Subject: Zoning By-Law Amendment – 780 Baseline Road

File Number: ACS2024-PRE-PS-0041

Report to Planning and Housing Committee on 31 January 2024

Document 9 – Shadow Study

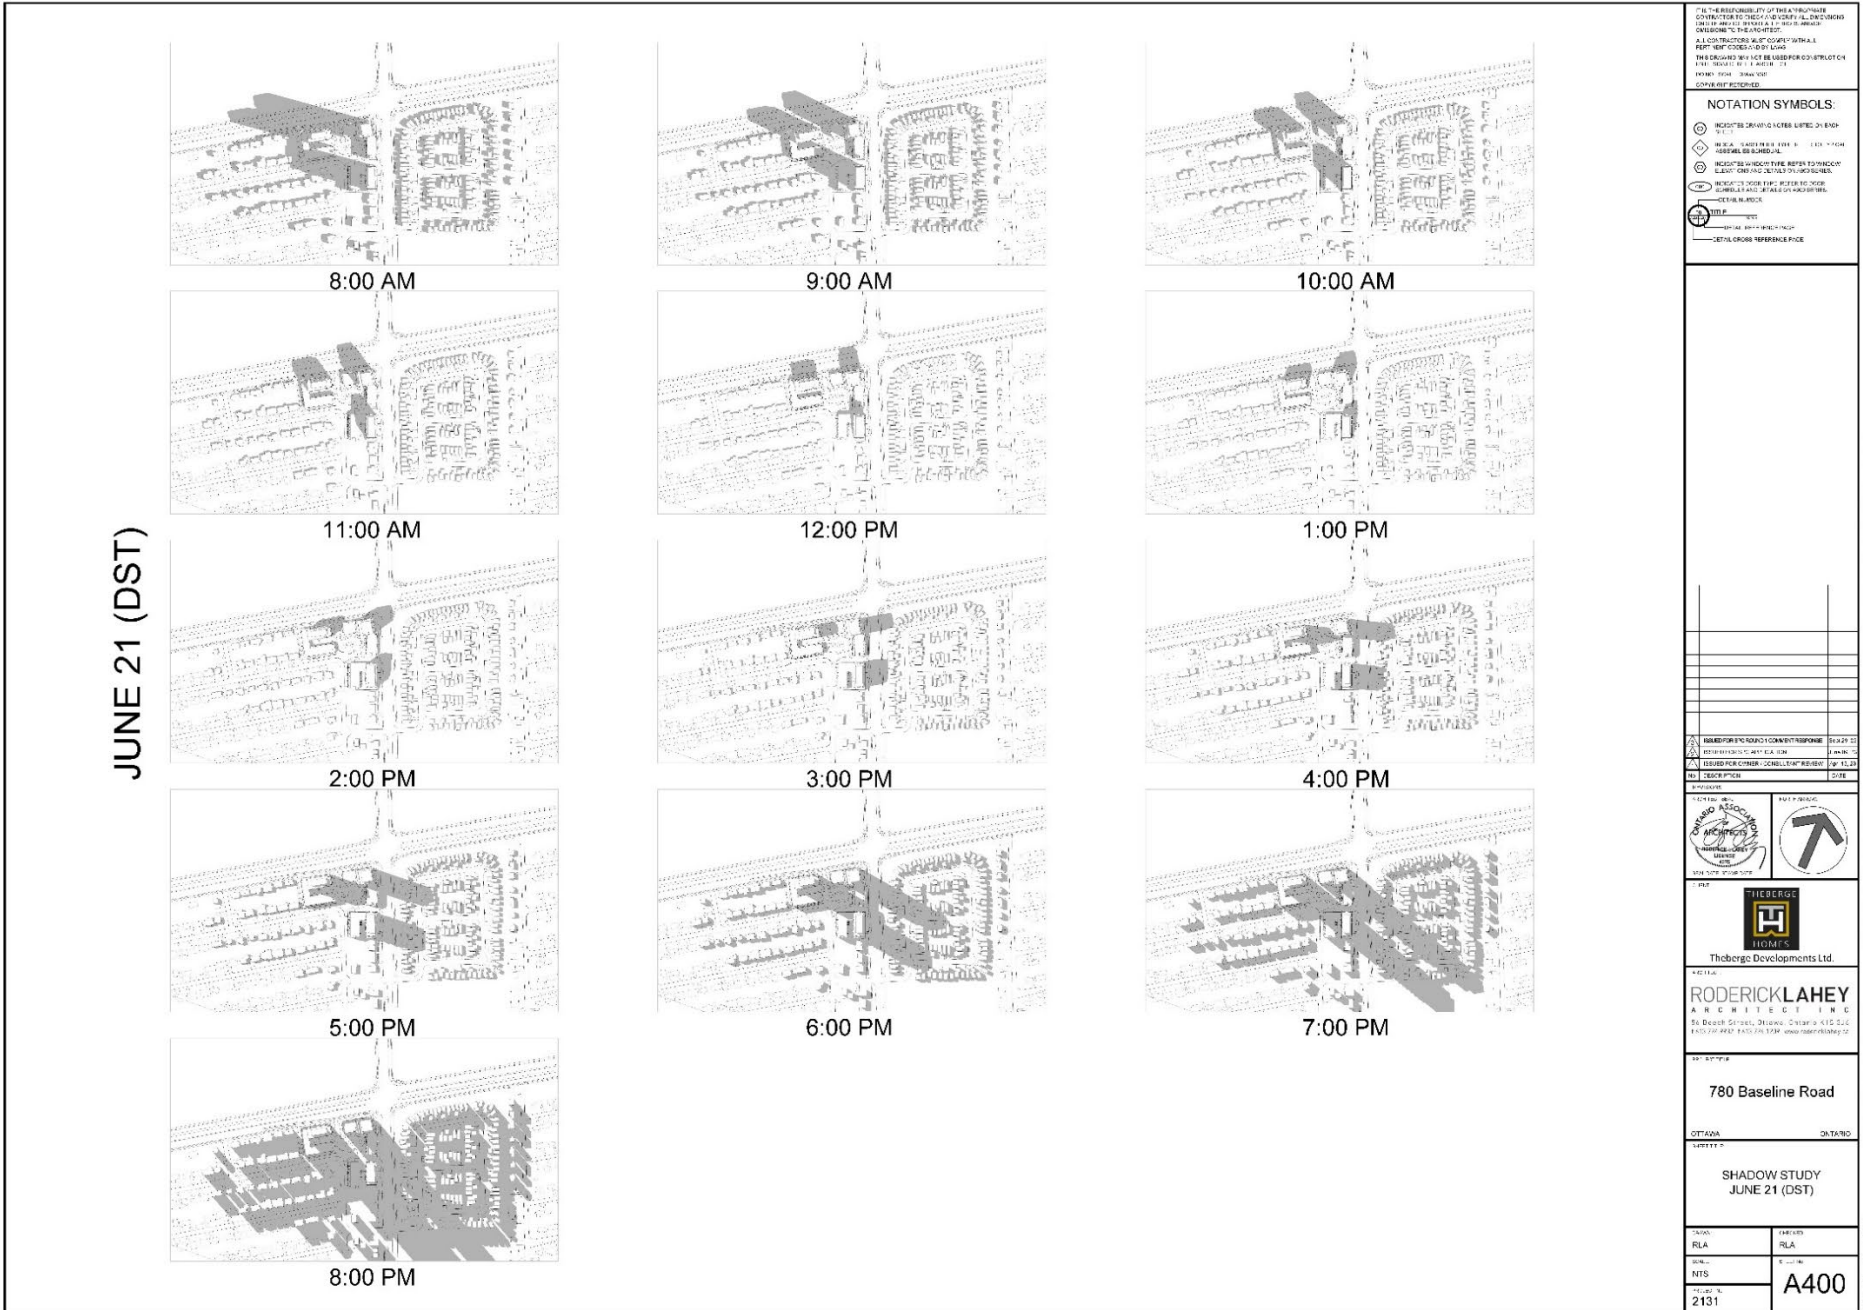
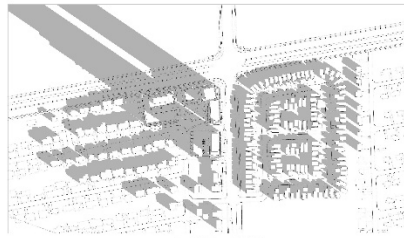
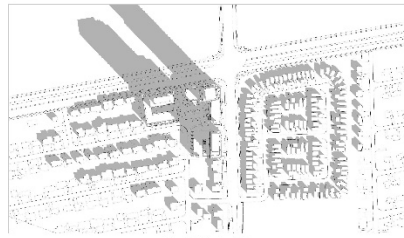
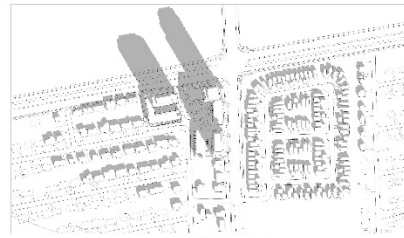
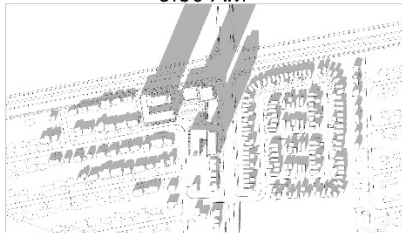
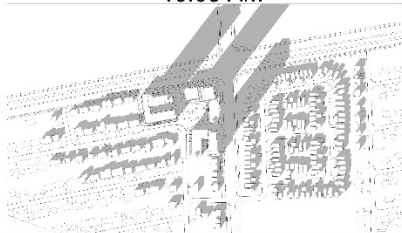
3. Concerned with shadows casting onto the intersections of Baseline Road and Fisher Avenue. Further concern these shadows would create icy and dangerous driving conditions.
4. The height of the building will block too much light to those who live behind the fence on Malibu Terrace.
5. Concern that the shadow studies are incomplete, failing to accurately show the impact of the proposal.

Staff Response to 3-5: The shadow studies were deemed to be complete and evaluated for consistency with the City's requirements. Upon review, they were deemed to be acceptable, consistent with required evaluation criteria in the City's Shadow Analysis Terms of Reference.

Figure 1. Shade maps for 780 Baseline Road. Top Map includes Tower A 78m, B 78 m and C 102m. Bottom map is only for Tower A 78m.

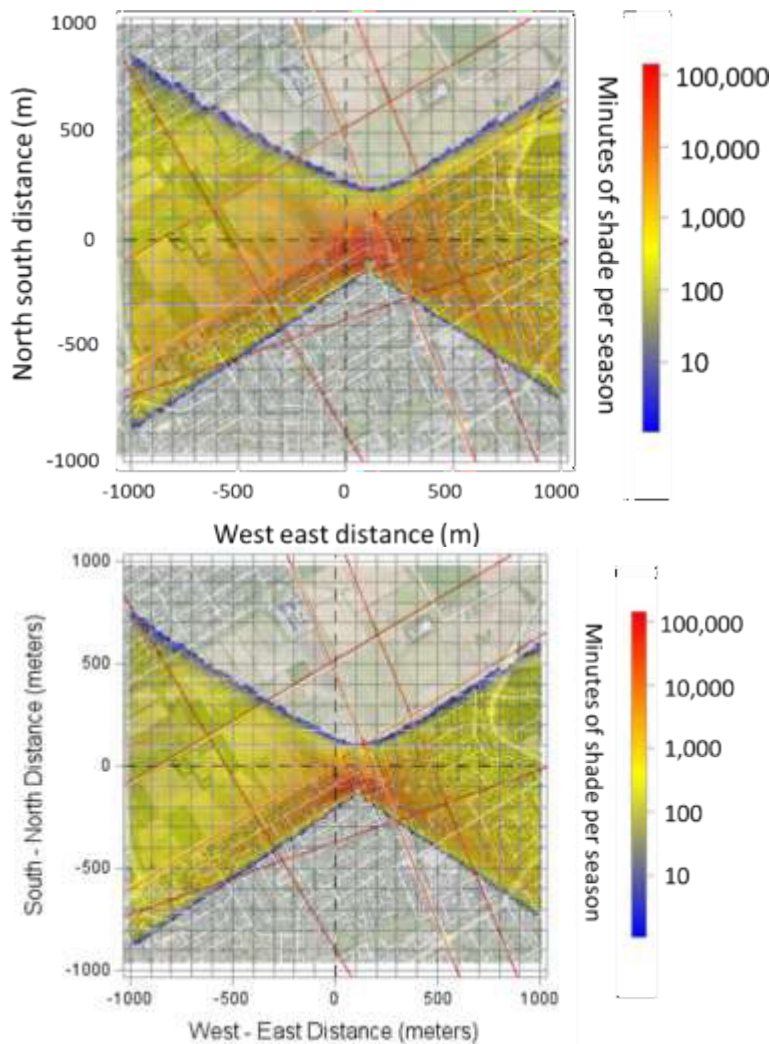
1. The attached figure 1 shows a 4 square kilometre block centred on the proposed towers at 780 Baseline Road. The colours over the area correspond to the shaded land with red being the greatest amount of shade followed by yellow and dark blue. The units are cumulative minutes of shade during the growing season. The figure shows that the proposed towers will result in significant shade cast on the Central Experimental Farm research lands both east and west of Fisher Avenue.

7. As seen in Figure 2b, the shade from only tower A is much less devastating to CEF research lands than when combined with Towers B and C. This is not only from the 24 metres reduction in height of tower A, but also its placement ~ 75 metres south of baseline road.

Figure 2a. Percent daily reduction in solar radiation April 01 to November 30 for Tower A, B and C at 780 Baseline Road. Polygon colours correspond to percentage daily amount of solar radiation reduction

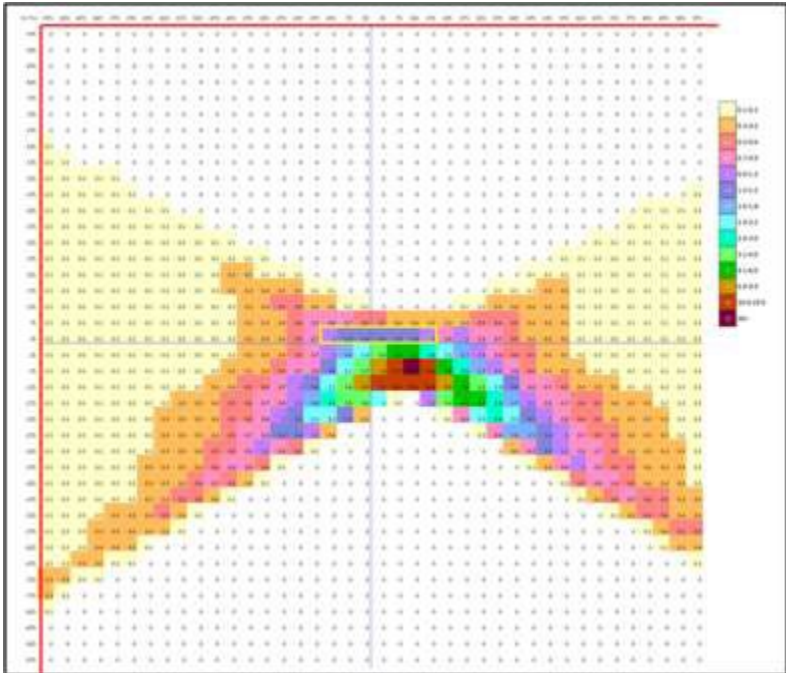
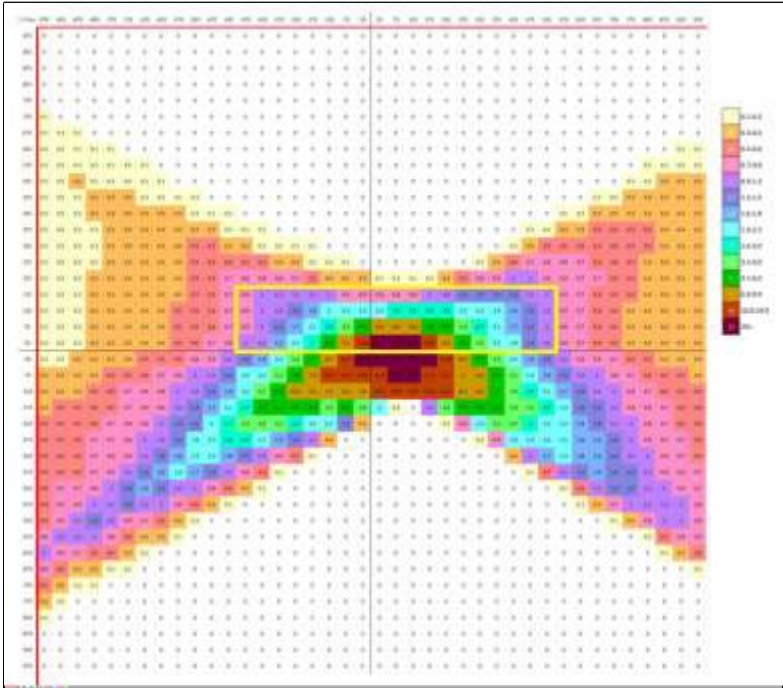
2. Figures 2a and 2b have been developed based upon 50 square metres polygons and show the percentage of light reduction per day for the growing season. The research lands directly opposite the proposed development will have daily solar radiation reduced by ~13 per cent per day. Moving west from Fisher the amount of shade received on the land is reduced until by 400 metres from the towers it is less than 1 per cent of solar radiation reduced per day. Moving north from the proposed towers, solar radiation reduction decreases and at 200 metres it is less than 1 per cent per day.

4. The yellow rectangles on Figure 2a and 2b show the area of research lands that will be detrimentally affected by the reduction in solar radiation.
5. Reducing the total amount of light reaching the research lands will reduce total plant photosynthesis, reducing yield and delaying harvest.

rectangles on Figure 2a and 2b and make them unusable for most field experiments. Increased light variability adds additional factors to research experiments that will make results impossible to interpret, and make the affected land unsuitable for research purposes.
